COUNCIL ASSESSMENT REPORT

Panel Reference	2018SCL021
DA Number	33.2018.1
LGA	Woollahra Council
Proposed Development	Demolition of all existing commercial buildings & construction of a new six (6) storey mixed-use building including 2 retail tenancies on ground floor, 5 storeys containing 23 residential units above, with 2 levels of below ground basement car parking, vehicular access via Gumtree Lane, provision of a through-site pedestrian link, and associated landscaping
Street Address	21, 23-25, 27 Bay Street DOUBLE BAY
Applicant/Owner	Pilmyth Pty Ltd; Thinqnet Bookings Pty Ltd (Owner) Thinqnet Bookings Pty Ltd c/o MHN Design Union (Applicant)
Date of DA lodgement	05.02.2018
Number of Submissions	Eight (8) – Including two (2) letters of support
Recommendation	Refusal
Regional Development Criteria (Schedule 4A of the Environmental Planning and Assessment Act 1979)	Capital Investment Value of \$22,290,000 (CIV > \$20 Million; Development applications lodged prior to 1 March 2018)

DEVELOPMENT APPLICATION ASSESSMENT REPORT

PANEL REFERENCE	2017SCL021
FILE No.	DA33/2018/1
ADDRESS	21, 23-25 & 27 Bay Street DOUBLE BAY
COUNCIL WARD	Double Bay
SITES AREA	820m ²
ZONING	B2 Local Centre
PRO

Section A – Indicating Building Height Limit and area of non-compliance (Source: Plans – MHNDUNION; Overlays: Woollahra Council).

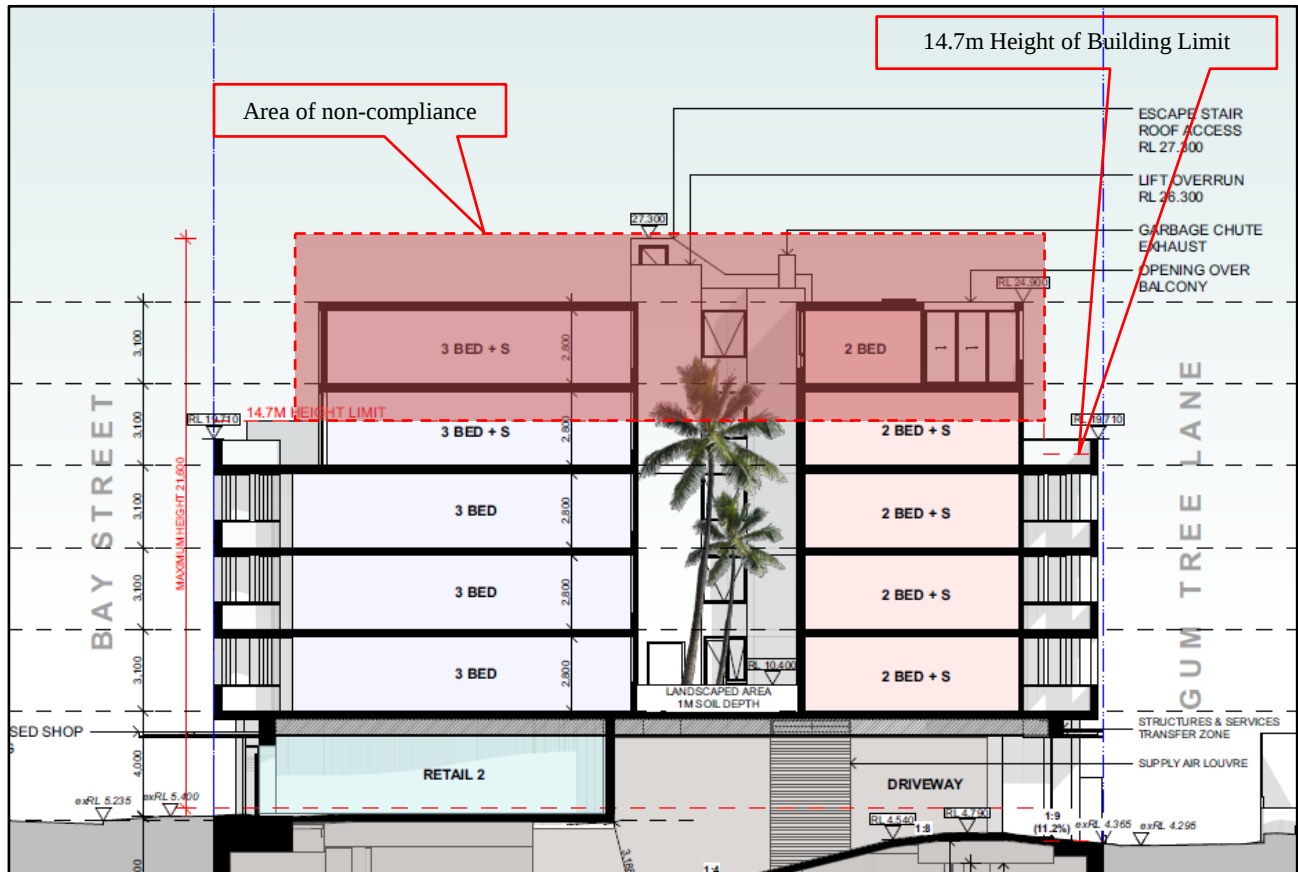
The proposal does not comply with the maximum building height prescribed by Part 4.3(2) of Woollahra LEP 2014. A Clause 4.6 written request has been submitted by the applicant and is assessed below.

Part D5.4.4 Bay Street (south)

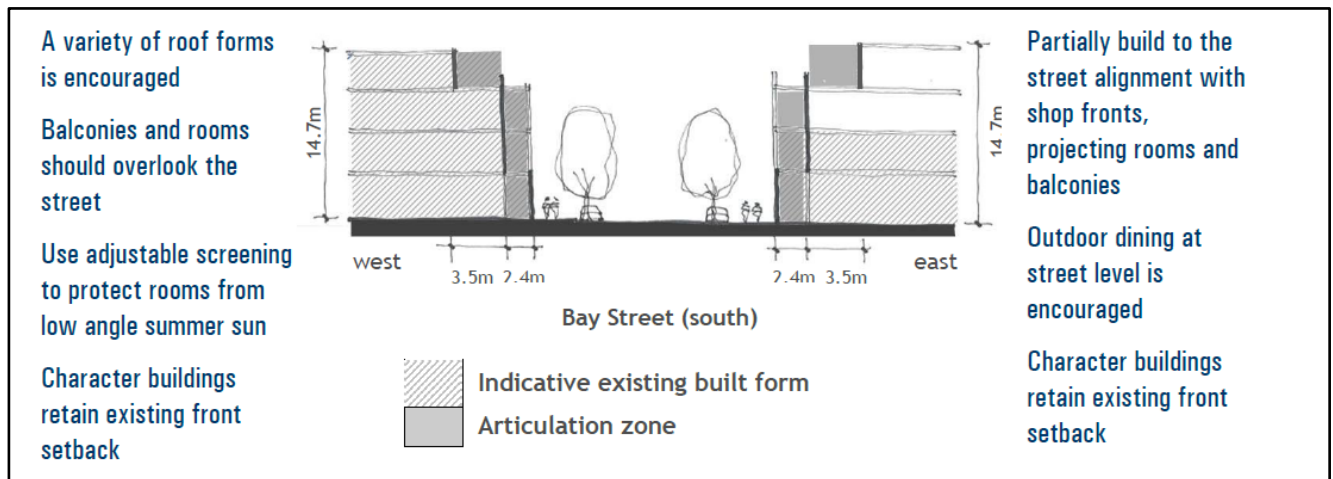
The proposed development does not achieve the Bay Street – Desired Future Character, Objective a), as the proposal does not maintain a three-four storey built form fronting Bay Street, nor does it provide a recessive upper floor level, as envisaged by the DCP.

The proposal therefore fails to satisfy the relevant criteria prescribed by this part.
